APPLICATION FOR SUBMITTAL OF POST-APPROVAL DOCUMENT

1. SUBMITTAL TYPE: (Is this a resubmittal? Yes <input type="checkbox"/> No <input type="checkbox"/>)			
Deferred Submittal <input type="checkbox"/>	Addendum Number: 01	Revision Number:	CCD Number: Category A <input checked="" type="checkbox"/> or B <input type="checkbox"/>

2. PROJECT INFORMATION:			
School District/Owner: Salinas City Elementary School District		DSA File Number: 27 47	
Project Name/School: Sherwood Elementary School		DSA Application Number 01 119995

(N) BUS DROP-OFF, PARKING, ACCESS RAMP & RESTROOM MODERNIZATION FOR: SHERWOOD ELEMENTARY SCHOOL

DEMO & PROPOSED FLOOR PLAN & ELEV. - STAFF RR A42
 NEW BUS DROP-OFF AND PARKING FOR:
SHERWOOD ELEM. SCHOOL
 110 SOUTH WOOD STREET
 SALINAS, CA 93905

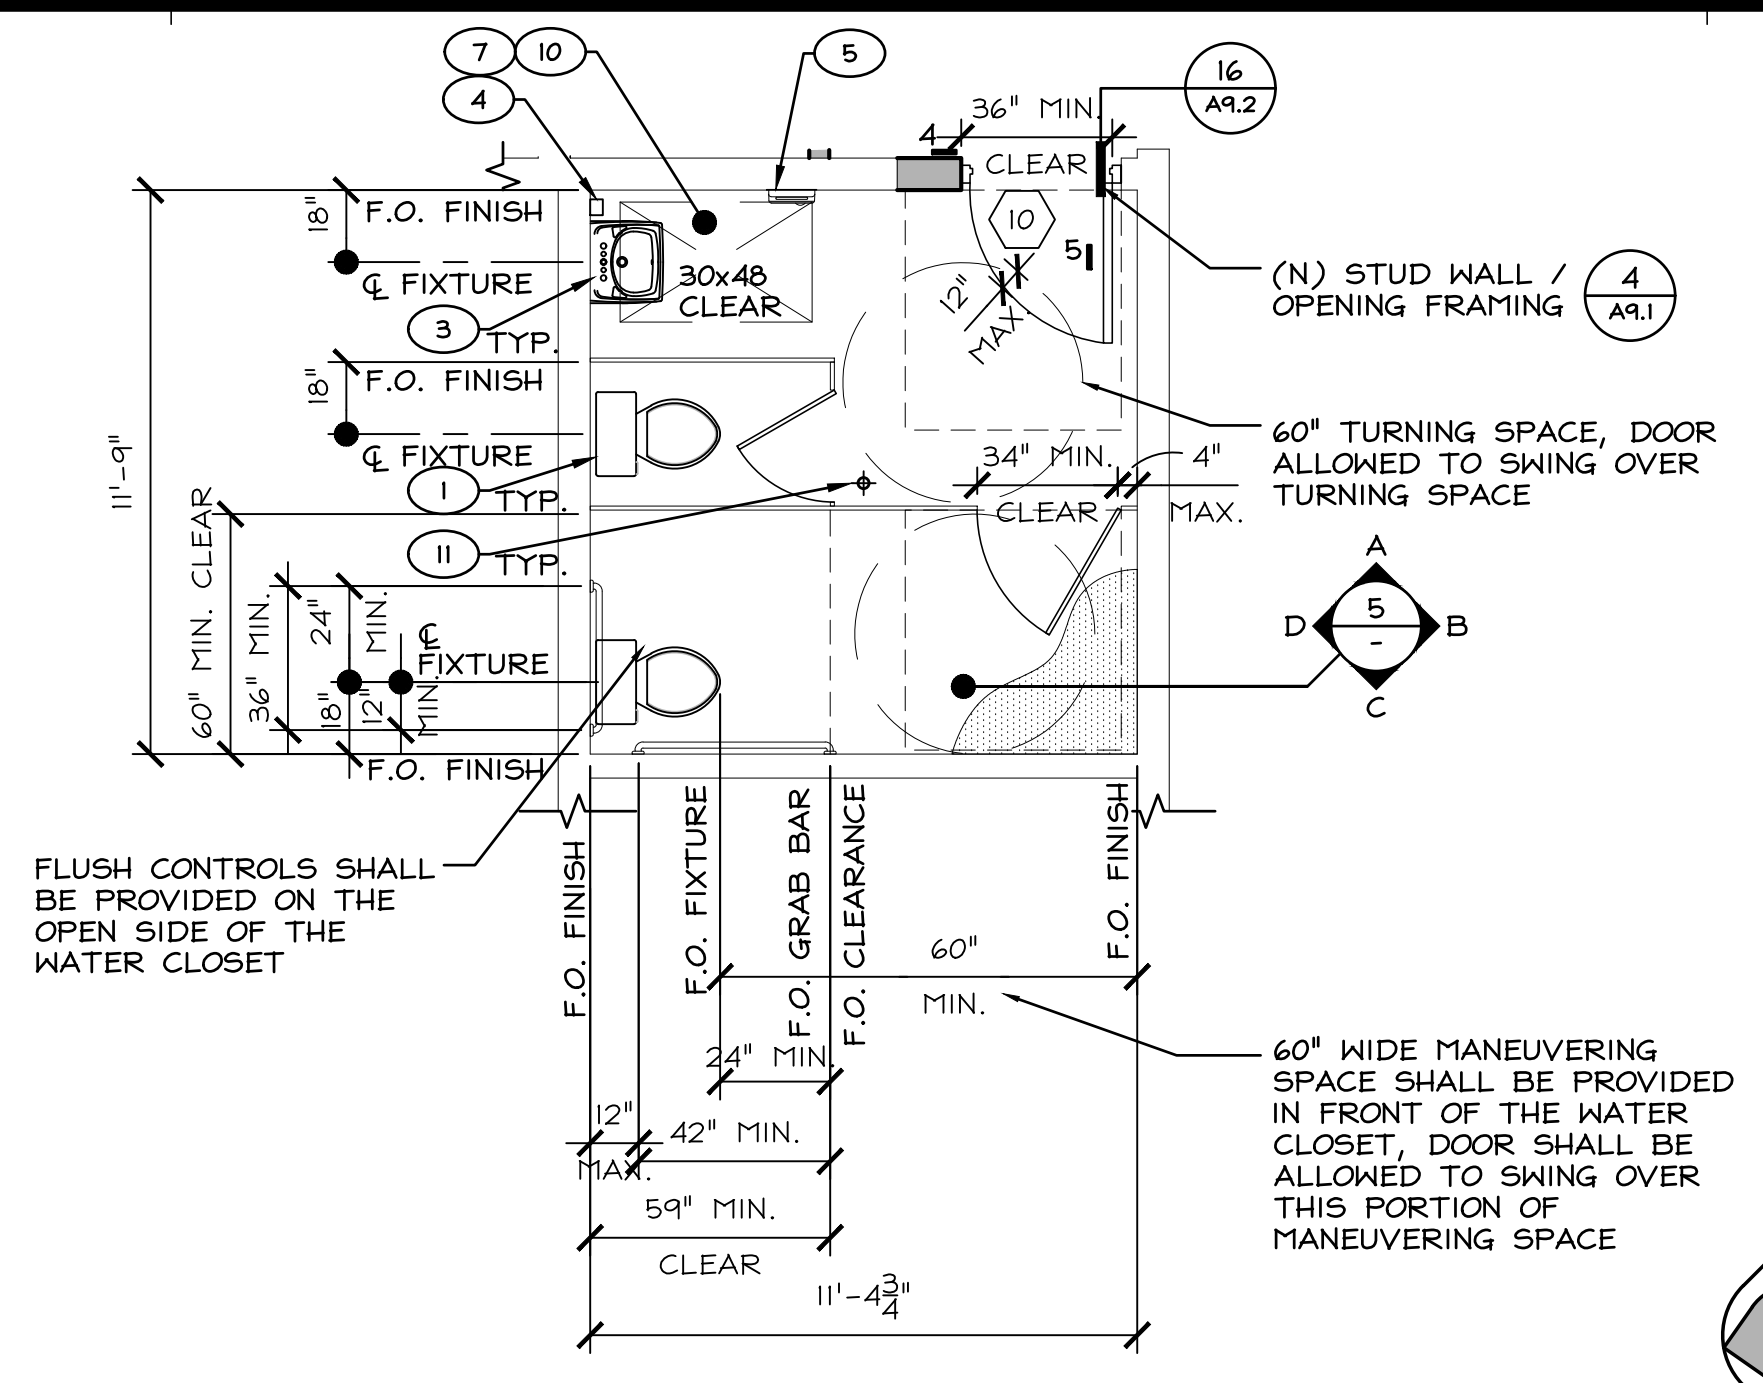
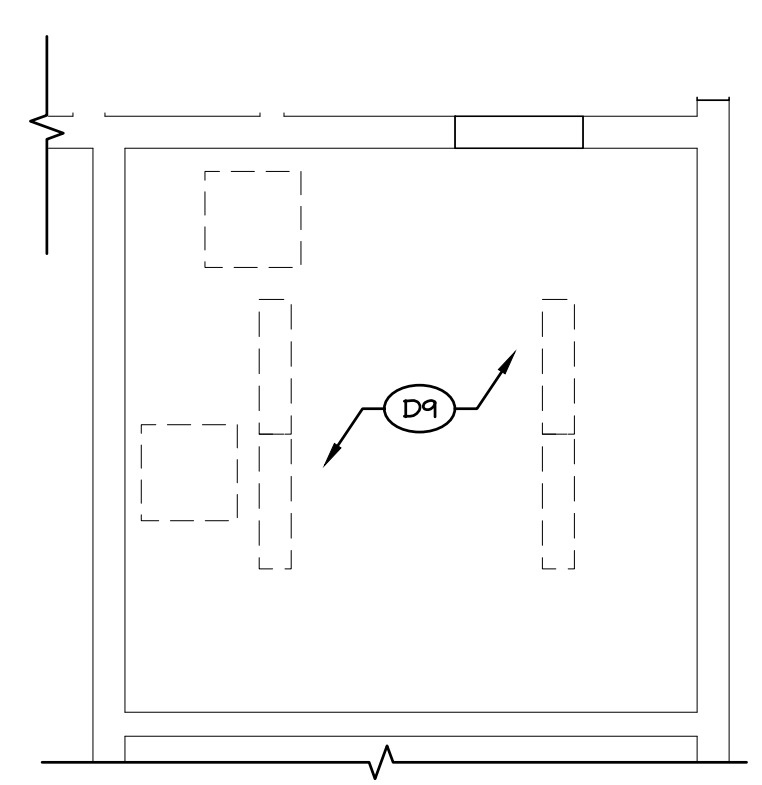
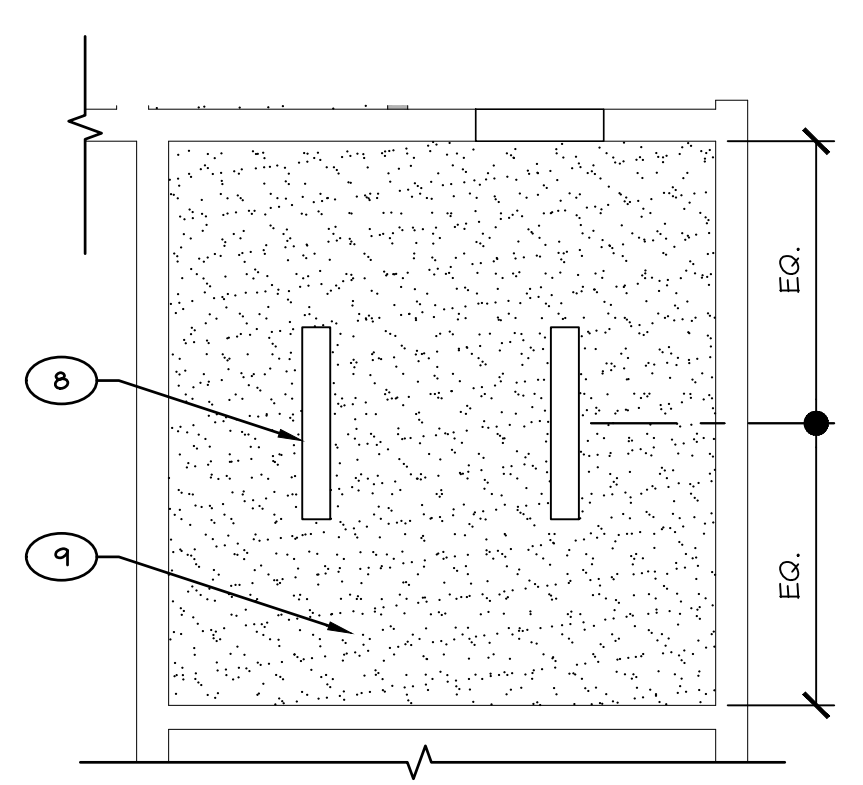
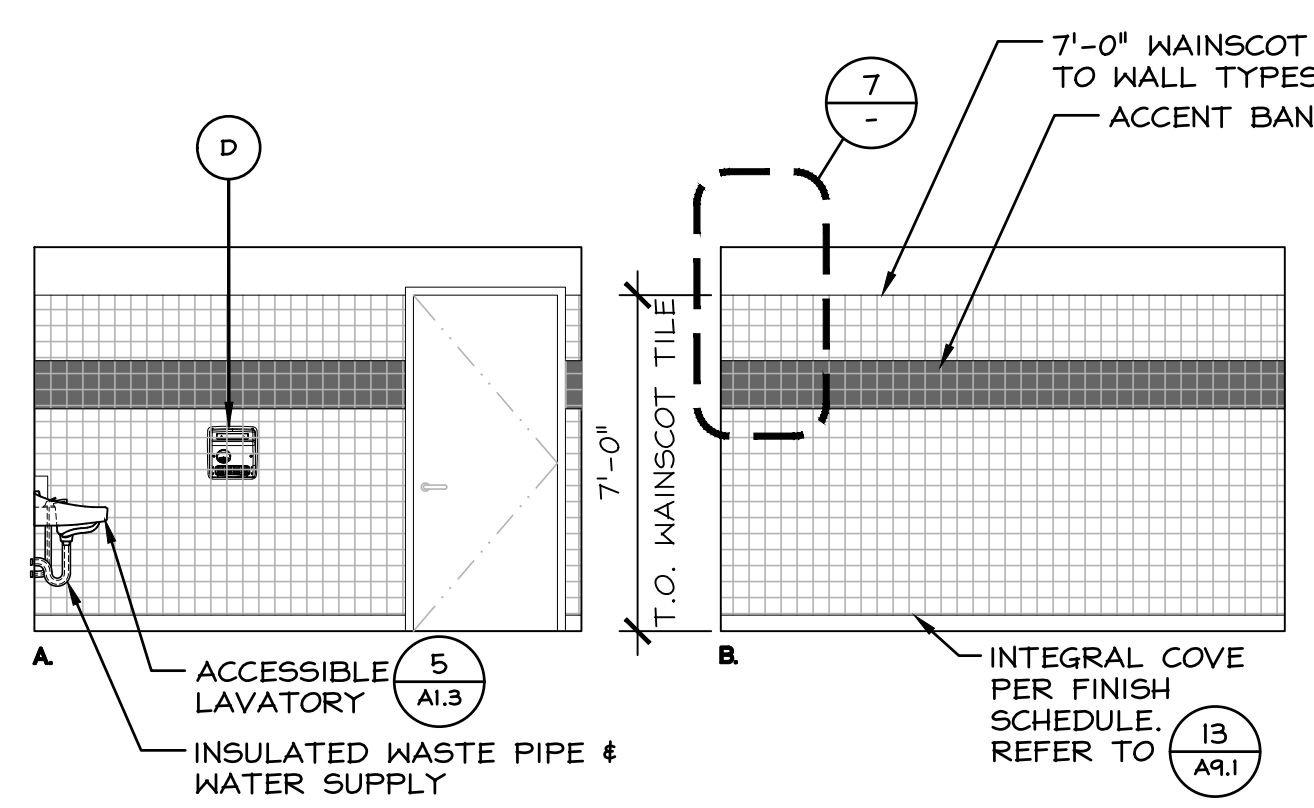
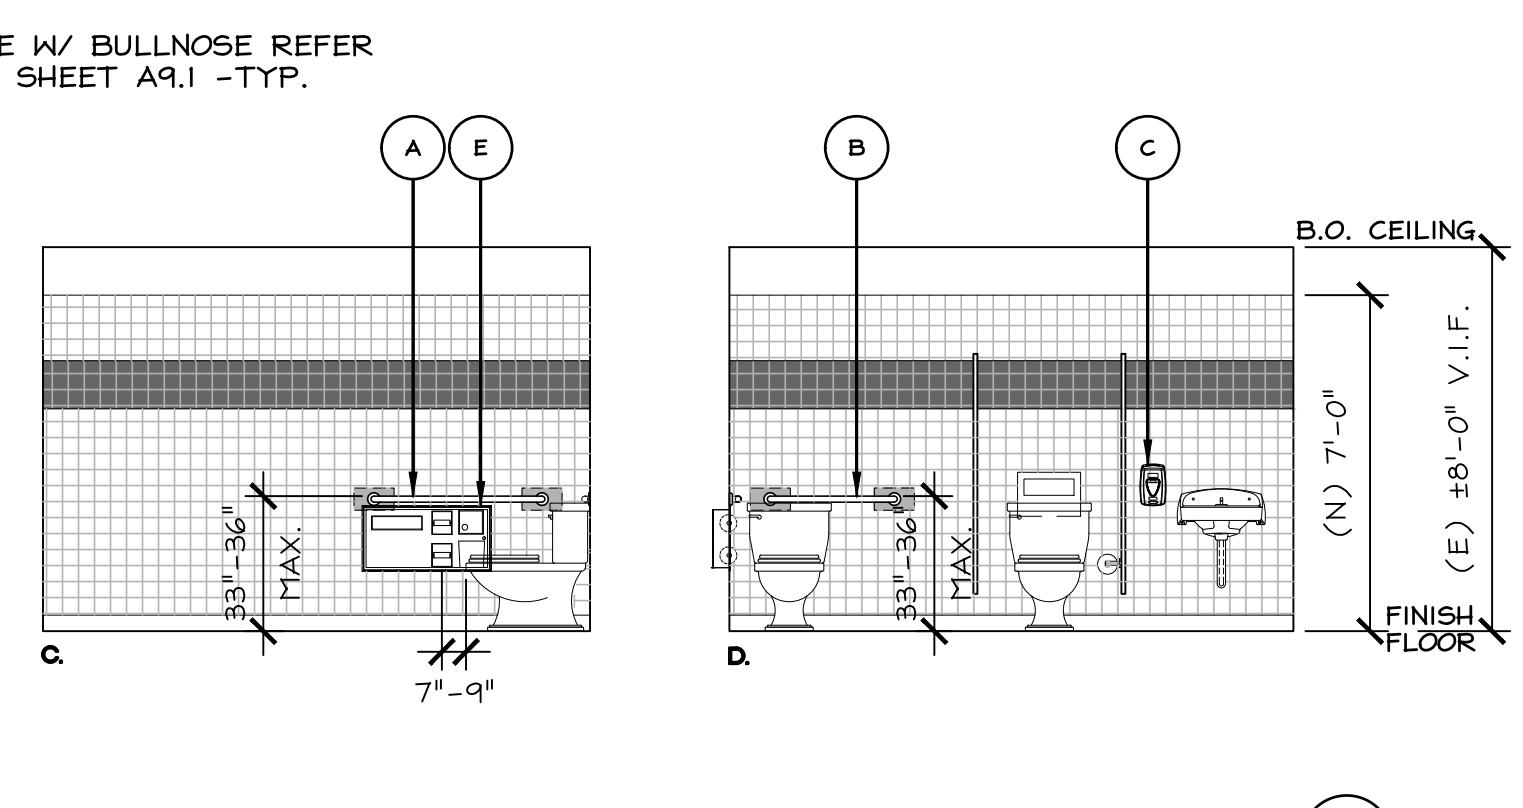
6. CONFIRMATION, DESCRIPTION AND LISTING OF DOCUMENTS:			
For addenda, revisions, or CCDs: CHECK THIS BOX <input checked="" type="checkbox"/> to confirm that <i>all</i> post-approval documents have been stamped and signed by the Responsible Design Professional listed on form <i>DSA 1: Application for Approval of Plans and Specifications</i> for this project. (For <i>Deferred Submittals</i> , refer to <i>IR A-18: Use of Construction Documents Prepared by Other Professionals</i> , and <i>IR A-19: Design Professional's Signature and Seal (Stamp) on Construction Documents</i> , when applicable, for signature and seal requirements.)			
Provide a brief description of construction scope for this post-approval document (attach additional sheets if needed): Addendum submitted to include one additional Staff Restroom into Scope of Work. We are proposing to convert an existing storage room into Staff Restroom. Fire alarm cut sheets provided as well.

List of DSA-approved drawings affected by this post-approval document: T1.1, A1.1, A2.7 (added new sheet), A3.1, P0.1, P1.1, P2.1, E3.1, E4.1, E5.1, FA0.1, FA1.1 and FA4.1.
